SECTION 00913 - ADDENDUM NUMBER 3

- 1.01 DATE: June 3, 2013
- 1.02 PROJECT: UNIVERSITY OF SOUTH CAROLINA - COKER 7TH FLOOR PHARMACY RENOVATIONS
- 1.03 PROJECT NUMBER: State Project #H27-6101, A/E #12023.01
- 1.04 OWNER: University of South Carolina
- 1.05 ARCHITECT: GMK Associates, Inc.
- TO: PROSPECTIVE BIDDERS
- 2.01 This Addendum forms a part of the Contract Documents and modifies the Bidding Documents dated April 23, 2013, and Addendum Number 1 issued May 22, 2013, and Addendum Number 2 issued May 28, 2013 with amendments and additions noted below.
- 2.02 Acknowledge receipt of this Addendum in the space provided in the Bid Form. Failure to do so may disqualify the Bidder.
- 2.03 This Addendum consists of 3 pages and the following attachments:
- A. SECTION 02080 - ASBESTOS ABATEMENT (FME CONSULTANTS)
 - B. SECTION 11531 - LABORATORY FUME HOODS
 - C. DRAWING M1.7
 - D. DRAWING AB-1 (FME CONSULTANTS)

UNIVERSITY OF SOUTH CAROLINA
COKER- 7TH FLOOR PHARMACY RENOVATIONS
COLUMBIA, SC

STATE PROJECT # H27-6101
A/E PROJECT # 12023.01

5.03 DRAWING M1.7

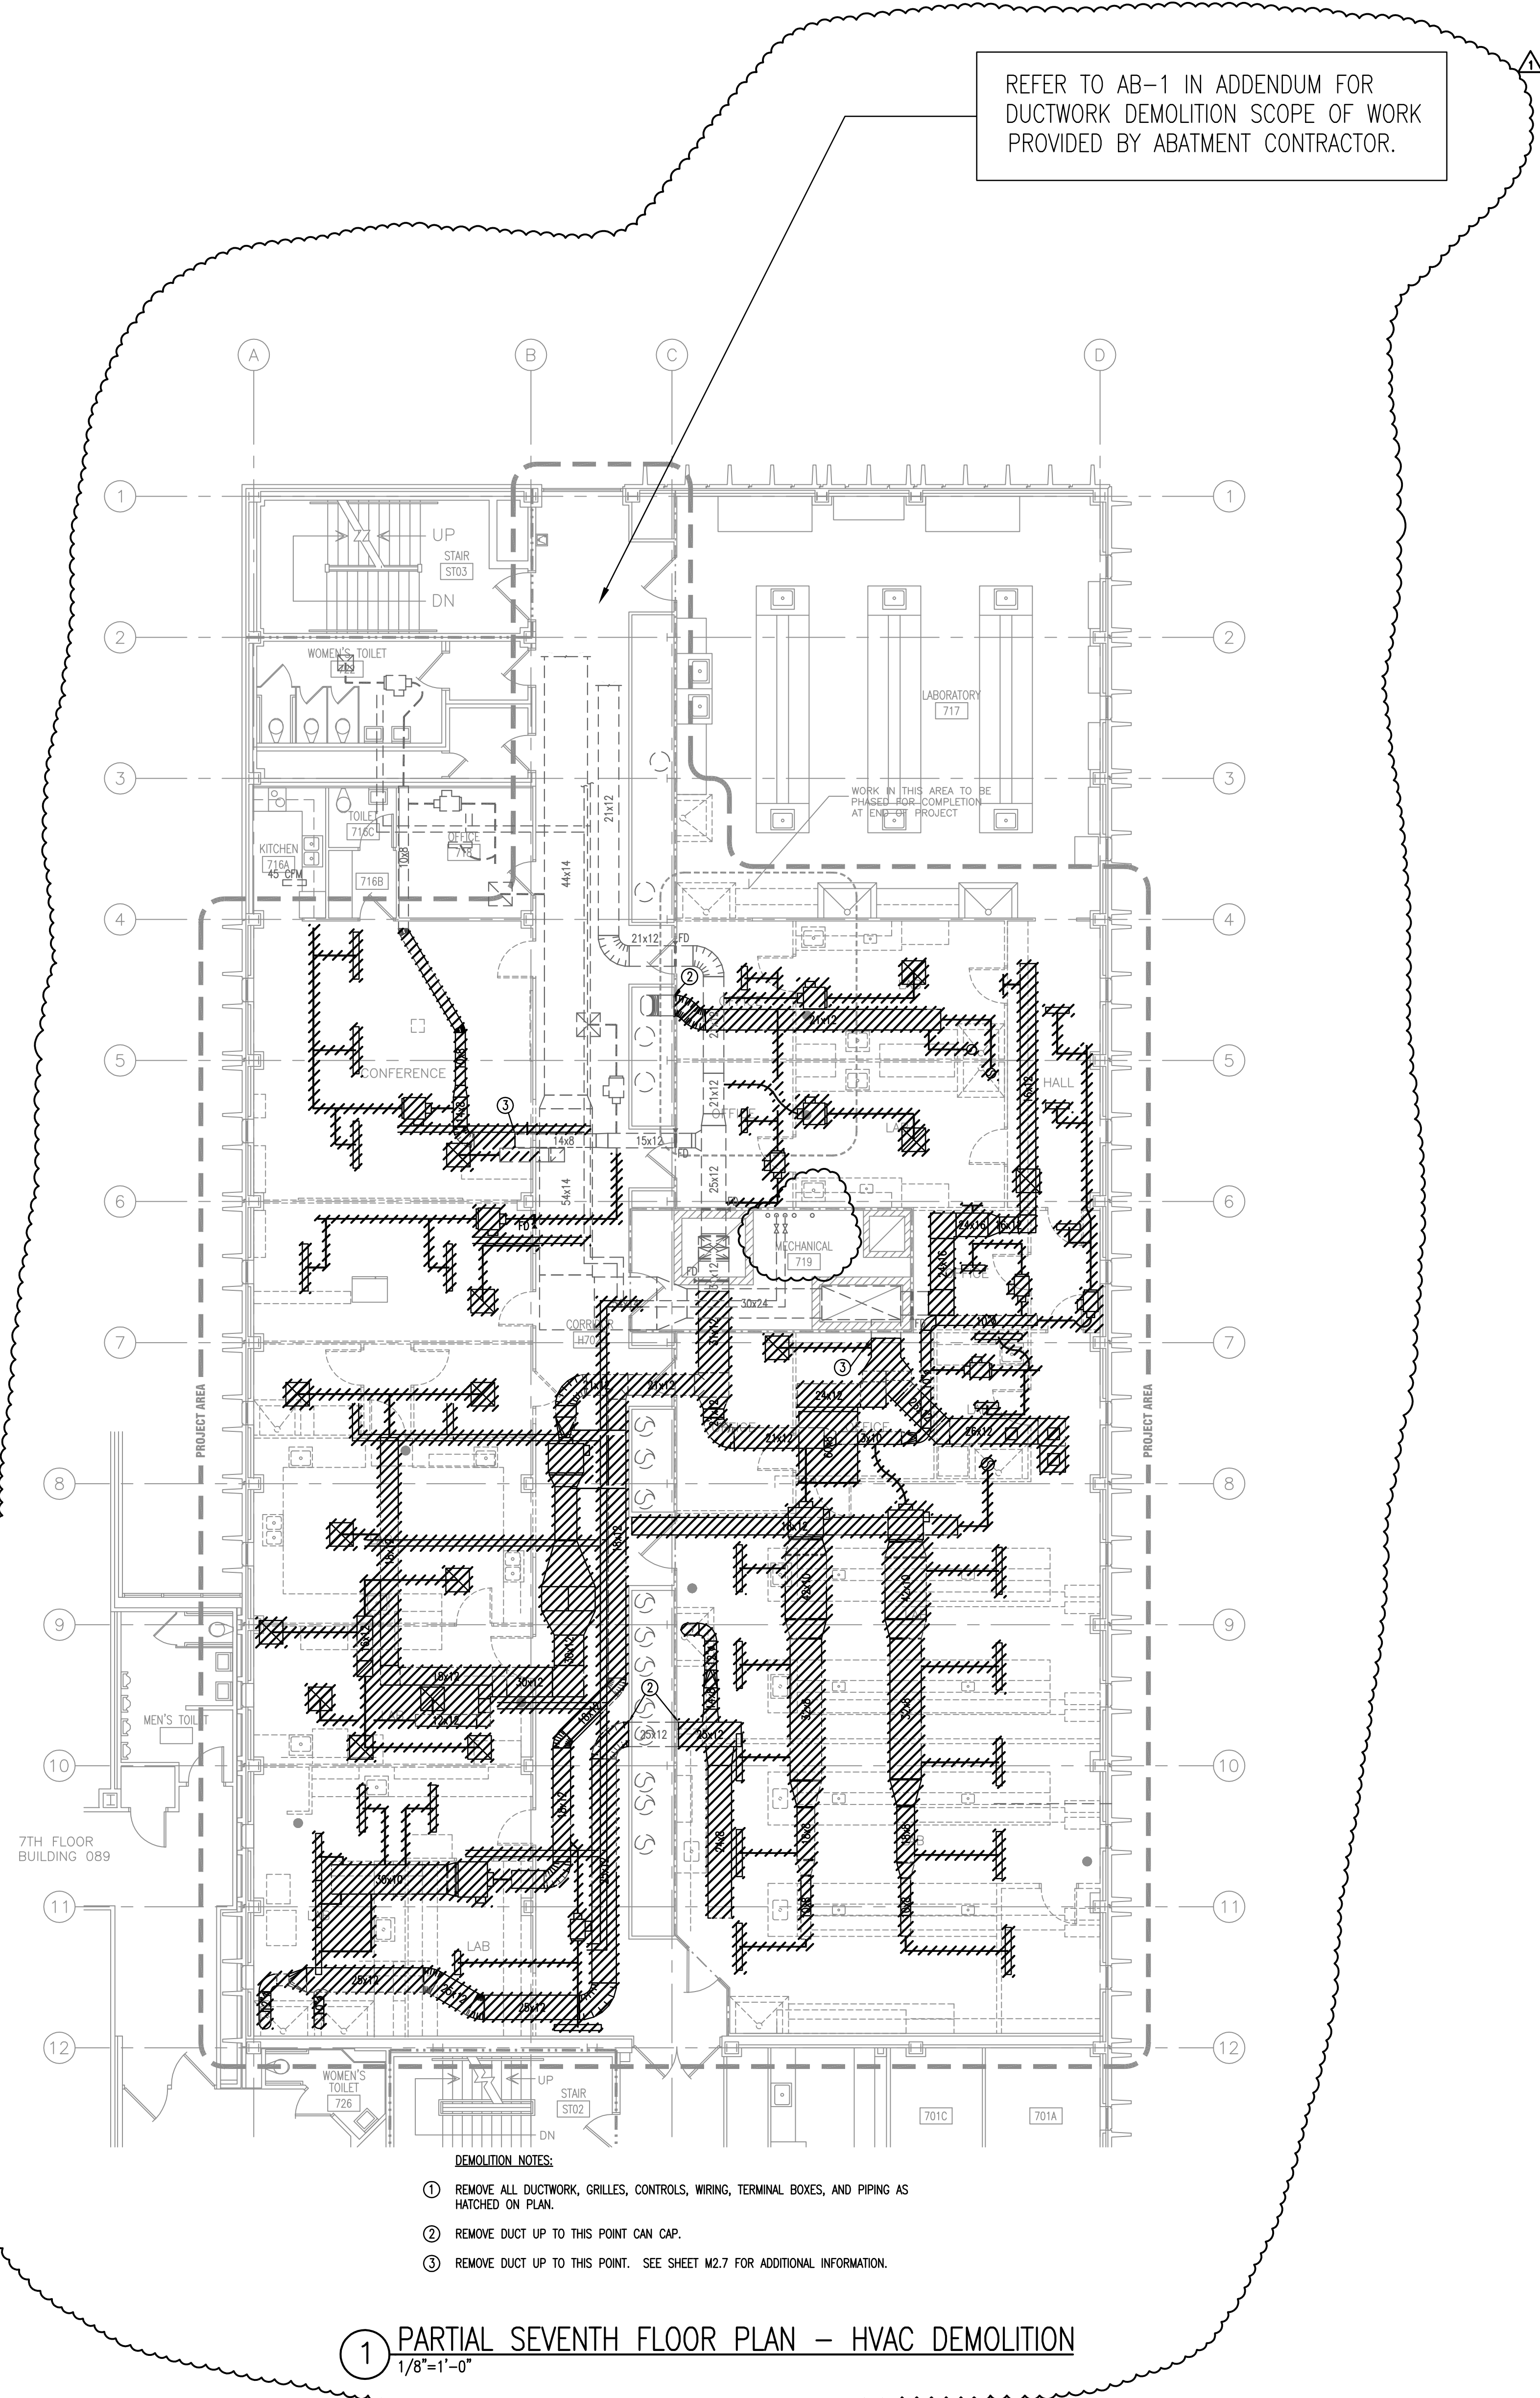
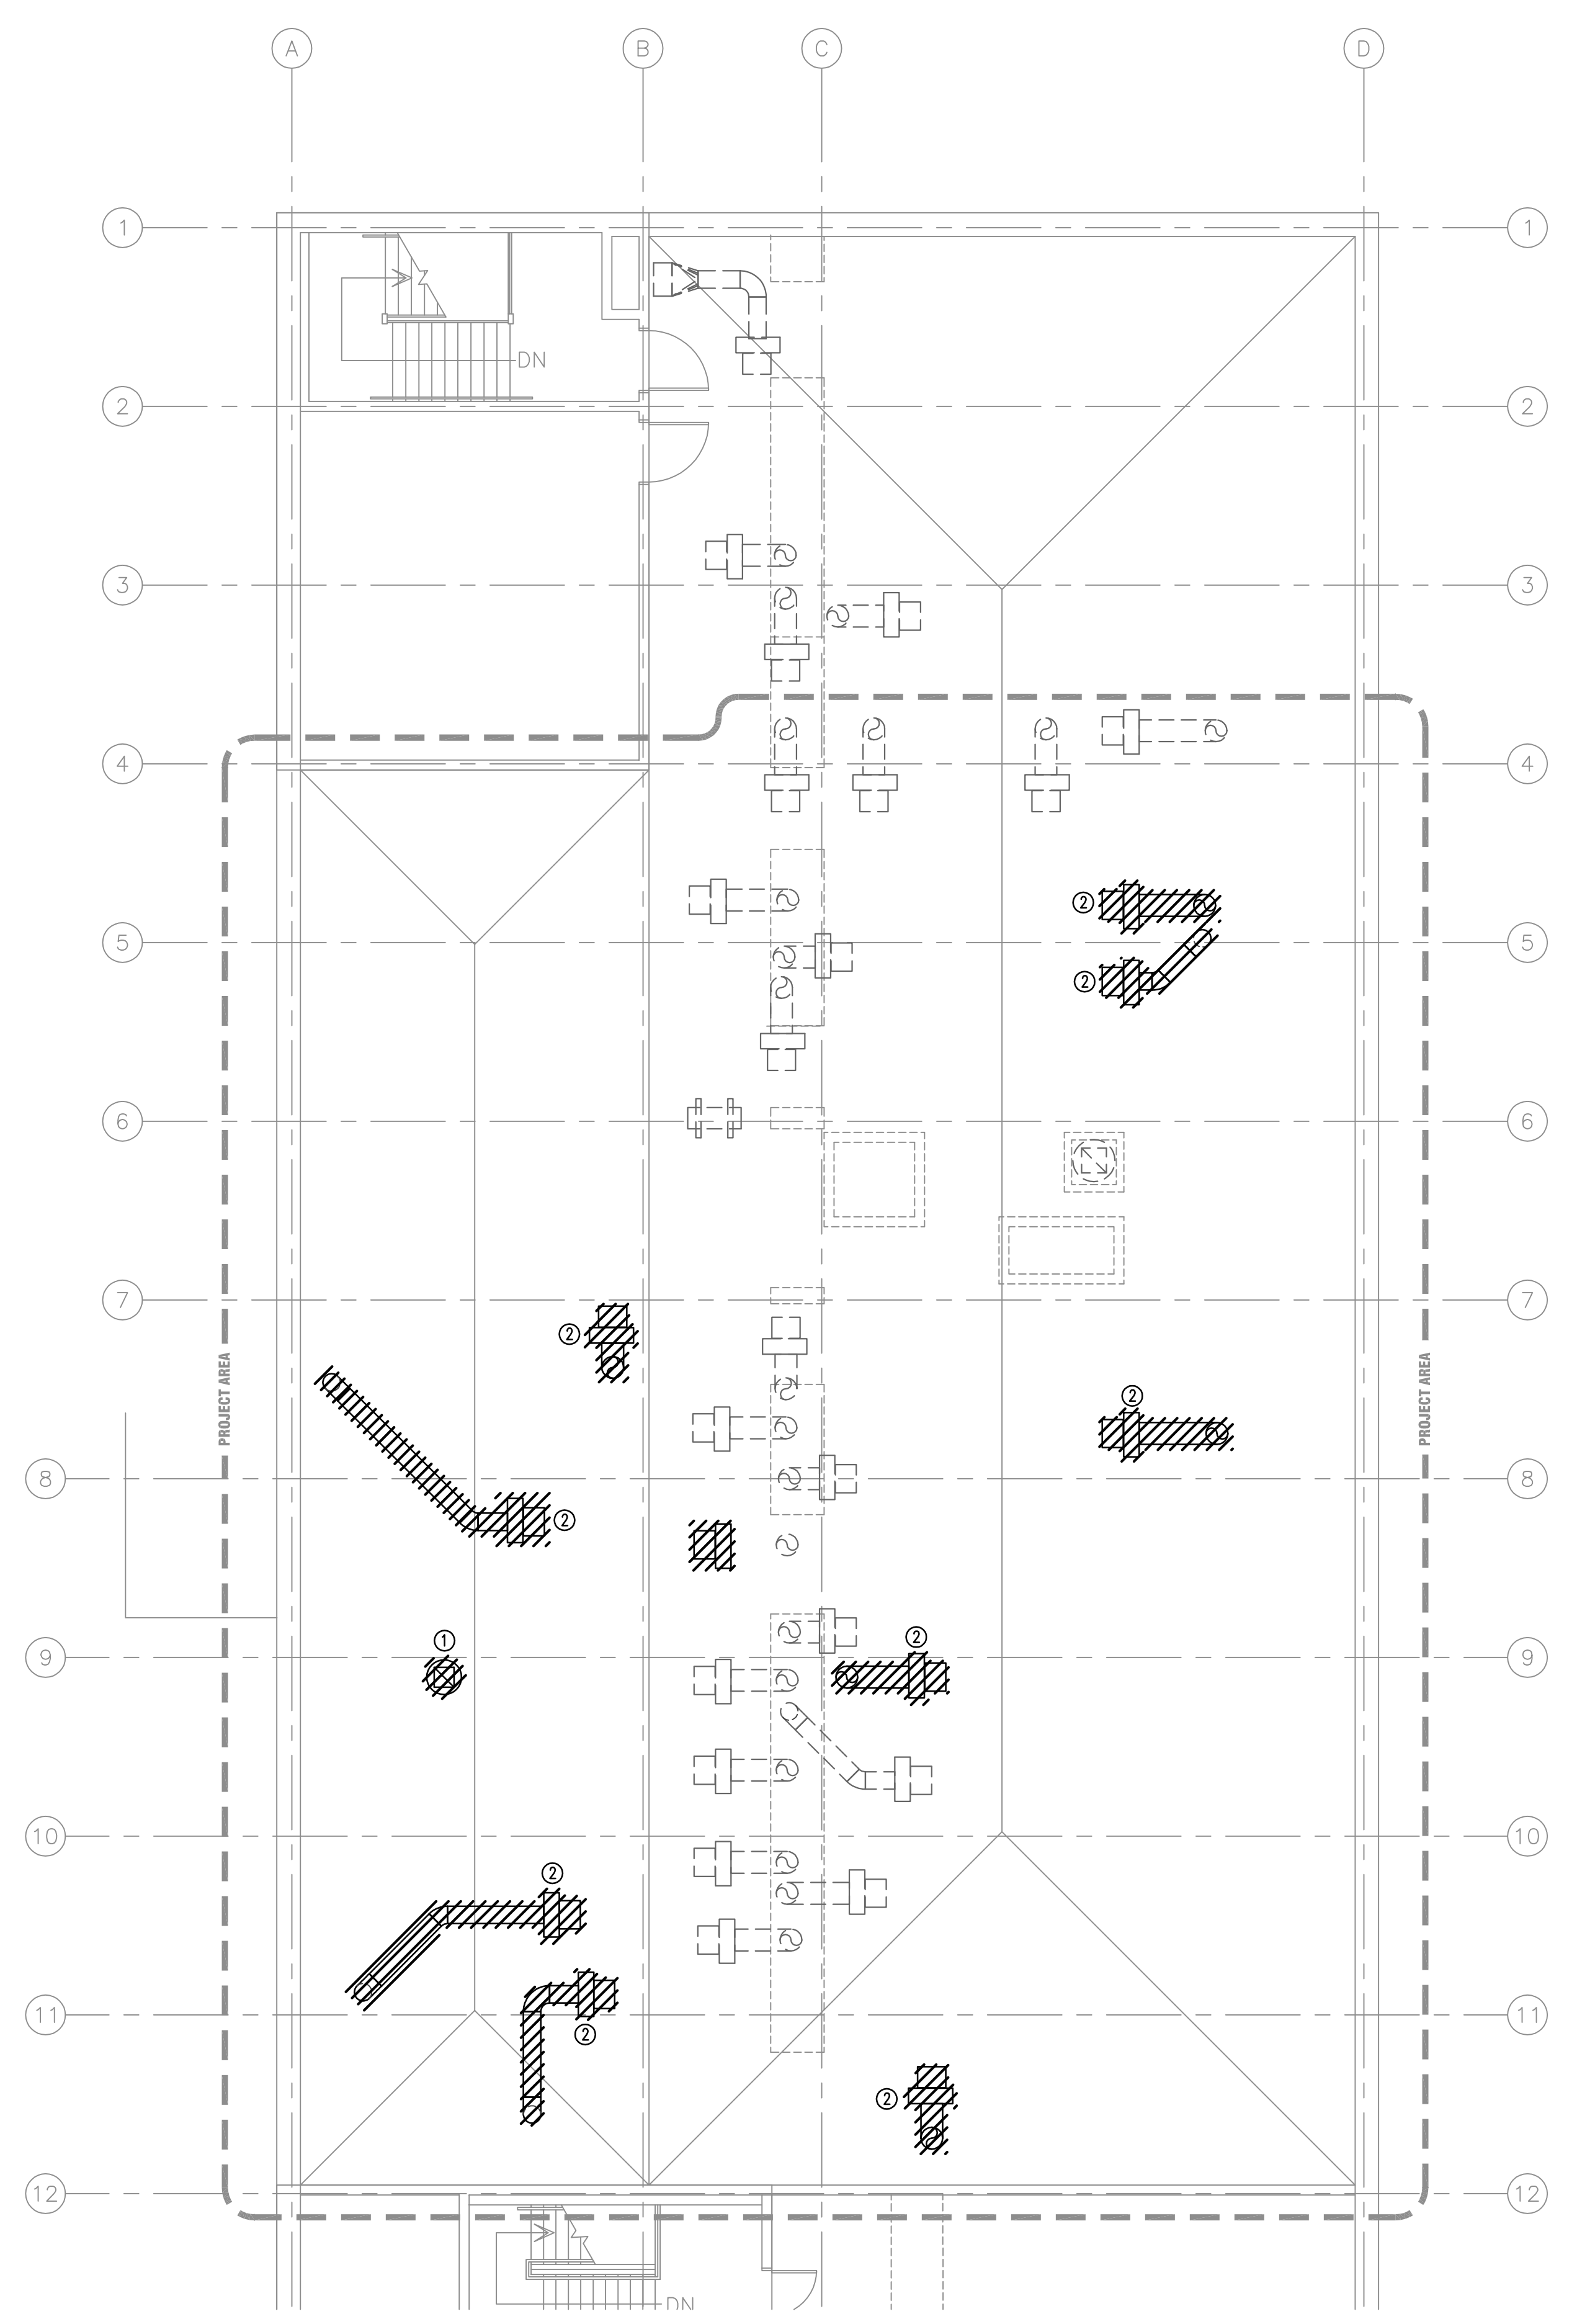
REFER TO AB-1 IN ADDENDUM FOR
DUCTWORK DEMOLITION SCOPE OF WORK
PROVIDED BY ABATEMENT CONTRACTOR.
